## STAFF REPORT

SUBJECT: Matador Estates  
H-2022-0043

Annexation of 5.09 acres of land with an R-4 zoning district; and preliminary plat consisting of 14 building lots and two (2) common lots on 4.84 acres of land in the R-4 zoning district for Matador Estates Subdivision.

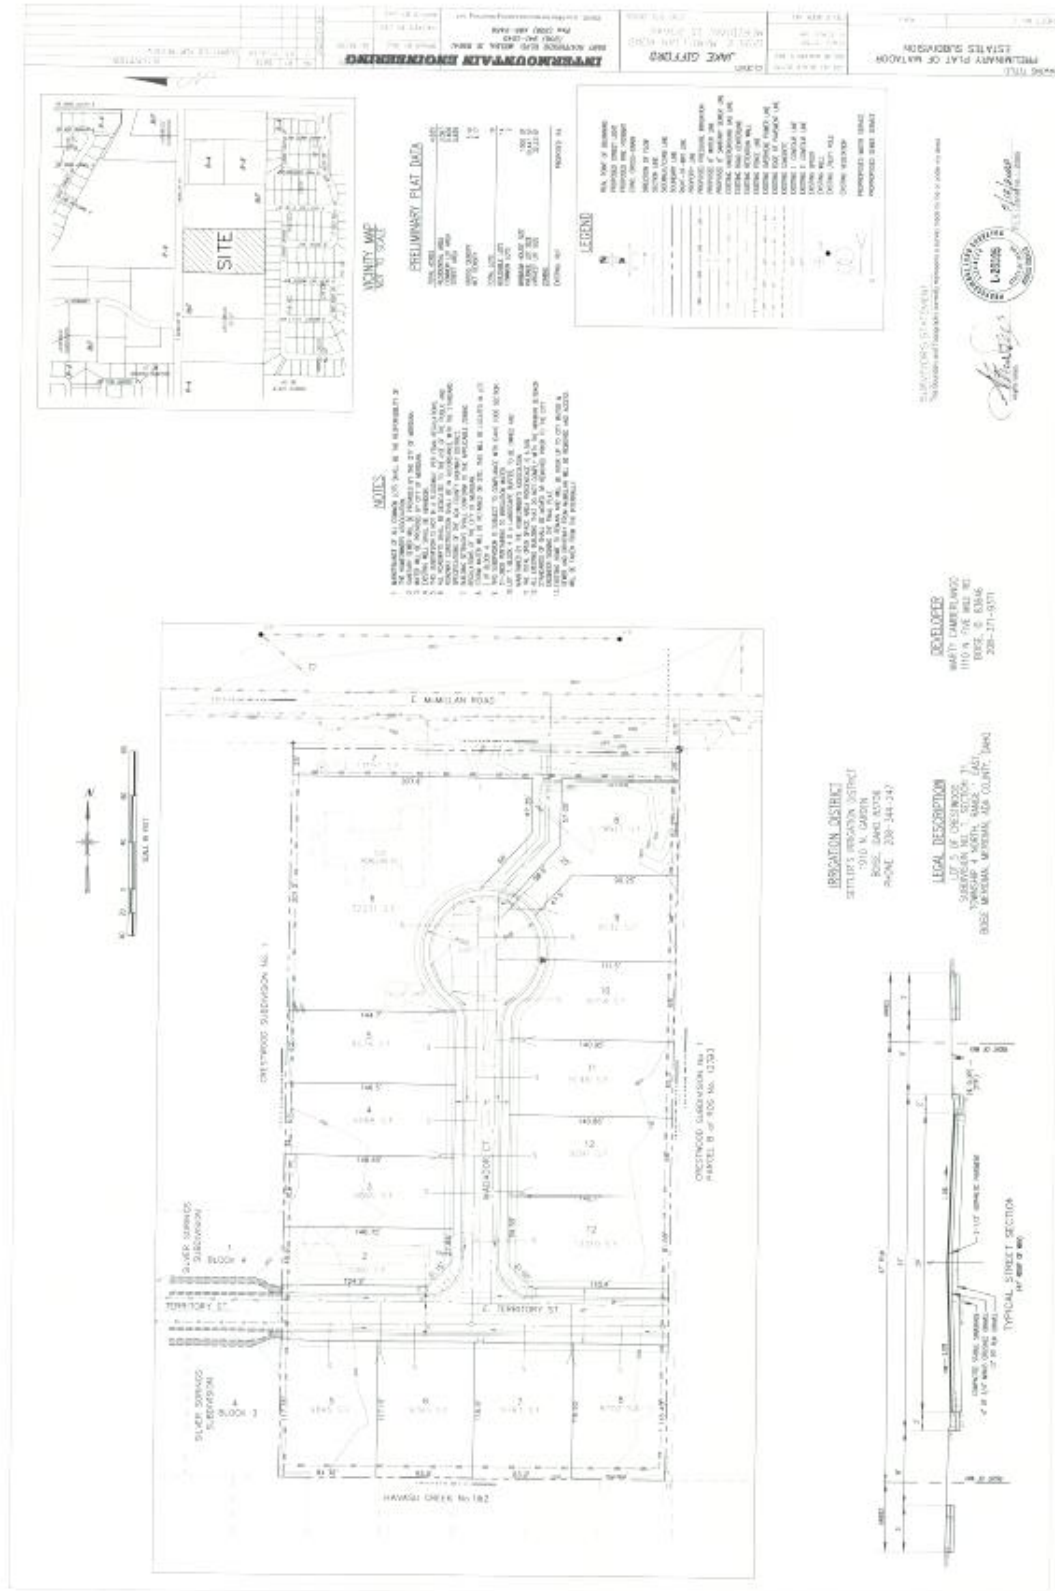
**Dimensional Standards (UDC 11-2):** The proposed plat and subsequent development is required to comply with the dimensional standards listed in UDC [11-2A-3](#) and [Table 11-2A-5](#) for the R-4 zoning district. **The proposed plat appears to comply with the dimensional standards of the district, except for the street frontage of Lot 8, Block 4 which should be a minimum of 30 feet; the plans should be revised accordingly.**

Landscaping is required along all pathways per the standards listed in UDC [11-3B-12C](#); **the landscape plan should be revised to include shrubs, along with the proposed trees and vegetative groundcover along the pathway on Lot 7, Block 4. A minimum of 5-feet should be provided outside of the easement area for trees; widen the lot if necessary to accomplish this.**

**Common Open Space & Site Amenities (UDC 11-3G-3):** Common open space and site amenities are required to be provided with development for properties of 5 acres or more in area per the standards listed in UDC [11-3G-3](#). **This site consists of 4.8 acres of land – the annexation boundary is 5.09 acres. Although not required by the UDC, Staff recommends as a provision of annexation in the DA that a minimum of 12% (or 0.58 acre) common open space is provided with development.** The landscape plan depicts 21,218.87 s.f. (or 0.49 acre) of common open space consisting of a 7,080 s.f. common area lot (Lot 2, Block 4), 2,840.74 s.f. of linear open space with a pathway (Lot 7, Block 4), and 50% of the street buffer along McMillan Rd. consisting of 4,178.13 s.f. **The plans should be revised to include an additional 0.09 acre of qualified common open space. If 8-foot wide parkways**

2. The final plat shall include the following revisions:
    - a. The minimum street frontage of Lot 8, Block 4 shall be a minimum of 30 feet as set forth in UDC [11-2A-3](#) and [Table 11-2A-5](#) for the R-4 zoning district.

- b. Graphically depict a 20-foot wide easement for the City of Meridian water main line on Lot 7, Block 4. Also, include a note with the recorded instrument number of the easement; a separate easement will be required.

- c. Provide a minimum 5-foot wide strip of land outside of the water main line easement noted above for landscaping along the pathway on Lot 7, Block 4.

- d. Correct the spelling of Matador Ct. (if spelled wrong).
  3. The landscape plan submitted with the final plat shall include the following revisions:

C. Landscape Plan (dated: 7/15/2021)

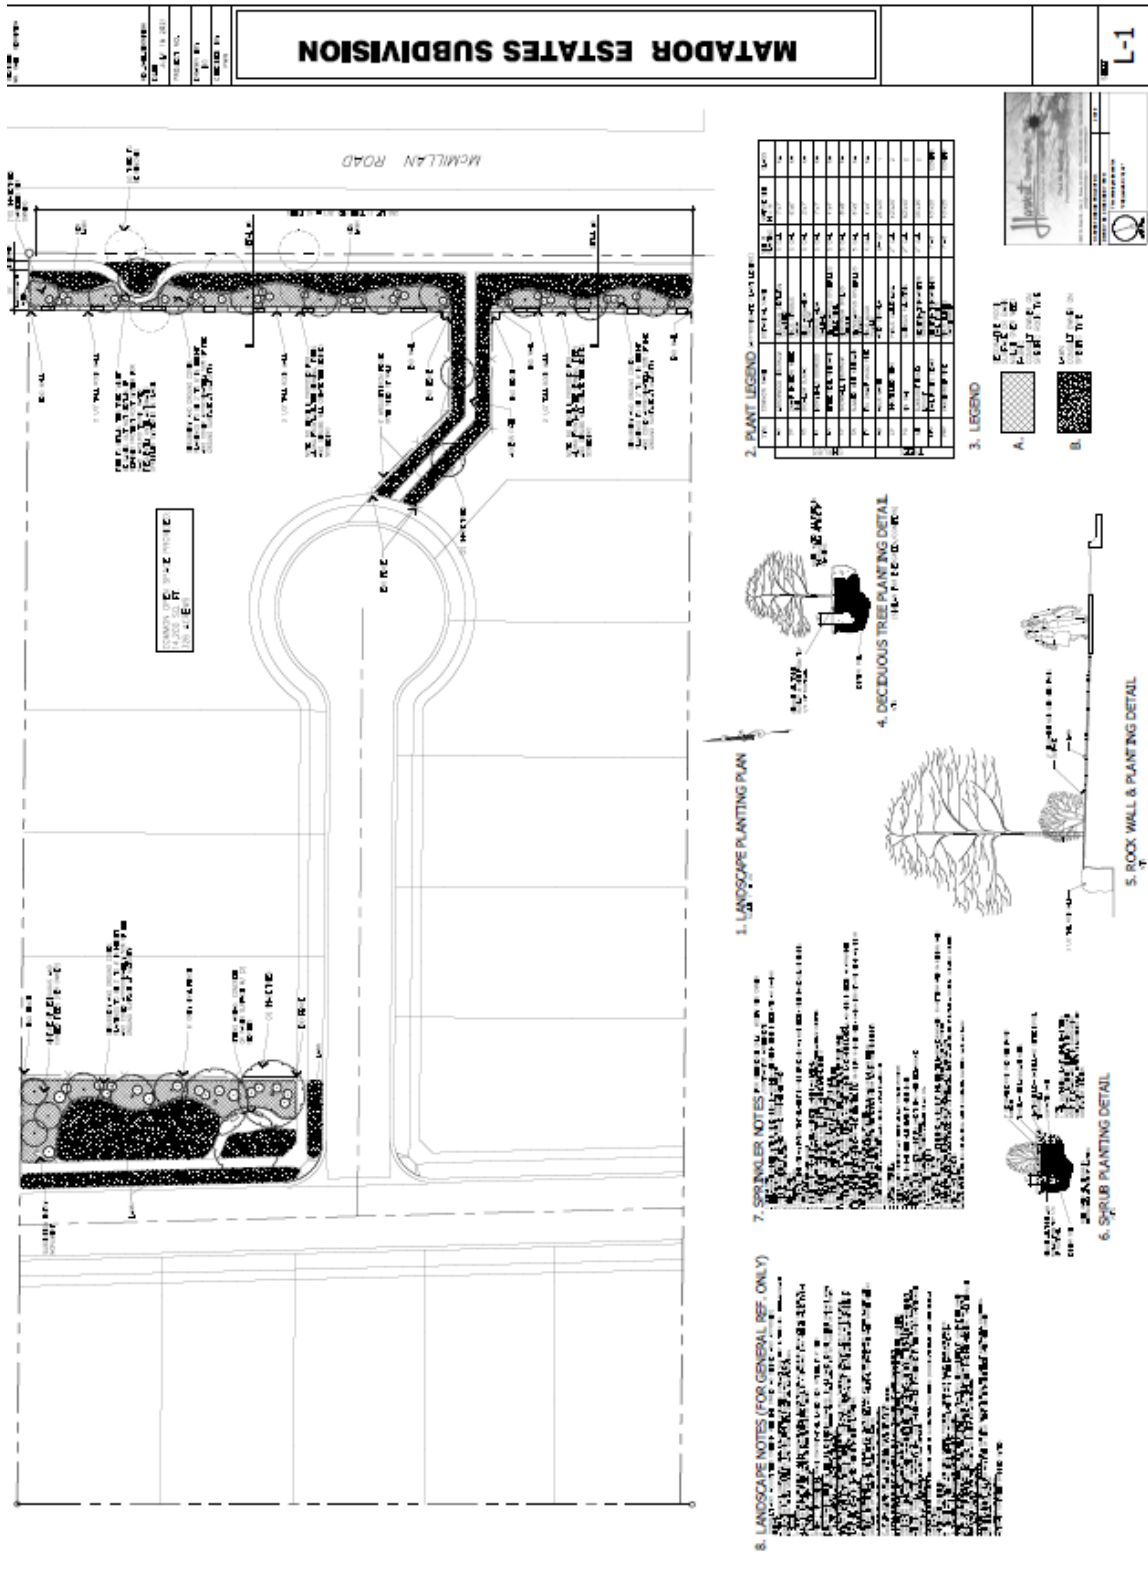
**Landscaping (UDC 11-3B):** A 25-foot wide street buffer is required to be provided along E. McMillan Rd., an arterial street, per the standards listed in UDC [11-3B-7C](#). A 25-foot wide buffer with a berm is proposed along McMillan with 10 shade trees, shrubs and groundcover. **A detailed landscape plan should be submitted with the final plat that complies with the aforementioned standards; detail #5 on Sheet L-1 should include the proposed berm along E. McMillan Rd.; and the location of the edge of paving should be depicted on the plan.** If the unimproved street right-of-way is ten (10) feet or greater from the edge of pavement to edge of sidewalk or property line, the developer shall maintain a ten-foot compacted shoulder meeting the construction standards of the transportation authority and landscape the remainder with lawn or other vegetative ground cover per UDC [11-3B-7C.5a](#).

A total of six (6) trees are proposed to be removed from the site (and possibly another one) as depicted on the landscape plan. **Mitigation is required to be provided per the standards listed in UDC [11-3B-10C.5](#). The Applicant should coordinate with the City Arborist (Kyle Yorita [kyorita@meridiancity.org](mailto:kyorita@meridiancity.org)) to determine mitigation requirements prior to removal of existing trees from the site.**

- a. The minimum street frontage of Lot 8, Block 4 shall be a minimum of 30 feet as set forth in UDC [11-2A-3](#) and [Table 11-2A-5](#) for the R-4 zoning district.

- b. Include mitigation calculations on the plan for existing trees that are proposed to be removed in accord with the standards listed in UDC [11-3B-10C.5](#). The Applicant shall coordinate with the City Arborist (Kyle Yorita [kyorita@meridiancity.org](mailto:kyorita@meridiancity.org)) to determine mitigation requirements *prior* to removal of existing trees from the site.

- c. Modify detail #5 on Sheet L-1 to include the proposed berm along E. McMillan Rd.
    - d. Depict location of the edge of paving on the plan. If the unimproved street right-of-way is ten (10) feet or greater from the edge of pavement to edge of sidewalk or property line, the developer shall maintain a ten-foot compacted shoulder meeting the construction standards of the transportation authority and landscape the remainder with lawn or other vegetative ground cover per UDC [11-3B-7C.5a](#).

- e. Depict street buffer landscaping in accord with the standards listed in UDC [11-3B-7C](#).
    - f. Depict landscaping (i.e. shrubs along with the trees and vegetative groundcover) along the pathway on Lot 7, Block 4 in accord with the standards listed in UDC [11-3B-12C](#).

- g. Include an additional 0.09-acre of qualified common open space per the standards in UDC [11-3G-3](#). *If parkways are provided toward this requirement, they must comply with the standards listed in UDC [11-3A-17](#) and [11-3G-3B.4](#); amend the plat if needed.*

- h. Provide a minimum 5-foot wide strip of land outside of the water main line easement noted above for trees to be planted along the pathway on Lot 7, Block 4.

- i. Depict a site amenity totaling a minimum of one (1) point. *If a structure for shade and picnic tables are added to the sitting area proposed on Lot 7, Block 4, this area could qualify as a picnic area, which is two (2) points; or, the Applicant may choose another qualified amenity from UDC [Table 11-3G-4](#). If a shade structures is proposed, provide a detail with the final plat application.*
